Access Compliance Report Public Rights-of-Way (Curb Ramps)

Main Street: BEACH_BLVD Cross Street: ROOSEVELT_AVE Location: NE

ADA ID: RPRK211001145945 Ramp Type: Type 1 - Perpendicular Diagonal Initial Pass/Fail: Fail Overall Compliance: No Severity Score: 15

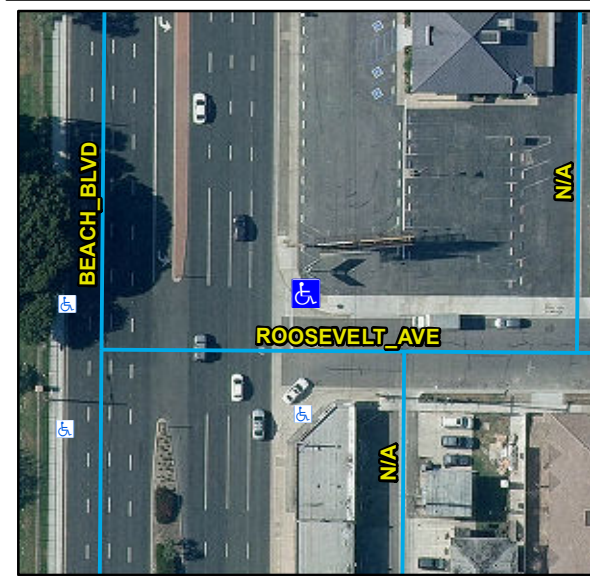
Compliance	Description	Data	Compliance	Description	Data
N/A	Ramp Length (in)	85	N/A	Flare Type LT	
Yes	Ramp Width (in)	48			N/A
Yes	Ramp Run Slope (%)	0	N/A	Flare Slope LT (%)	N/A
No	Ramp Cross Slope (%)	6.7	N/A	Flare Traversable LT	N/A
N/A	Landing Present	N/A	N/A	Flare Type RT	
N/A	Landing Length (in)	N/A			N/A
N/A	Landing Width (in)	N/A	N/A	Flare Slope RT (%)	N/A
N/A	Landing Run Slope (%)	N/A	N/A	Flare Traversable RT	N/A
N/A	Landing Cross Slope (%)	N/A	N/A	DWS Provided	N/A
N/A	Landing Movement Obstructed?	N/A	N/A	DWS Contrast	N/A
	Landing Movement Type	N/A	N/A	DWS Length (in)	N/A
N/A	Landing Shared	N/A	N/A	DWS Full Width	N/A
N/A	Clear Space	Yes	N/A	DWS Offset Left (in)	N/A
N/A	Clear Space To Crosswalk (in)	N/A	N/A	DWS Offset Right (in)	N/A
N/A	Marked Crosswalk 1	No	N/A	Marked Crosswalk 2	No
	Crossing 1 Direction	W		Crossing 2 Direction	S
	Marked Crosswalk 1 Width (in)	N/A		Marked Crosswalk 2 Width (in)	N/A

N/A	Ramp Inside Crosswalk 1	N/A	Yes	Ramp Inside Crosswalk 2	N/A
	Crossing 1 Slope (%)	6.8		Crossing 2 Slope (%)	1.3
	Crossing 1 Cross Slope (%)	1.5		Crossing 2 Cross Slope (%)	1
N/A	Gutter Ponding	N/A	No	Curb Slope	8.2
Yes	Gutter Lip Height (in)	0		Road Run Slope (%)	0.4
N/A	Gutter Run Slope (%)	N/A		Road Cross Slope (%)	3.9
N/A	Gutter Cross Slope (%)	N/A			
Yes	Overall Surface Condition: Acceptable		Yes	Perp Joint Present	Yes
	Cross Gutter Present?	No		Spandrel Present?	No
	Replace Cross Gutter?	N/A		Replace Spandrel?	N/A

Possible Solutions:
Remove & Replace Curb Ramp With Two New Directional Ramps or Equivalent.
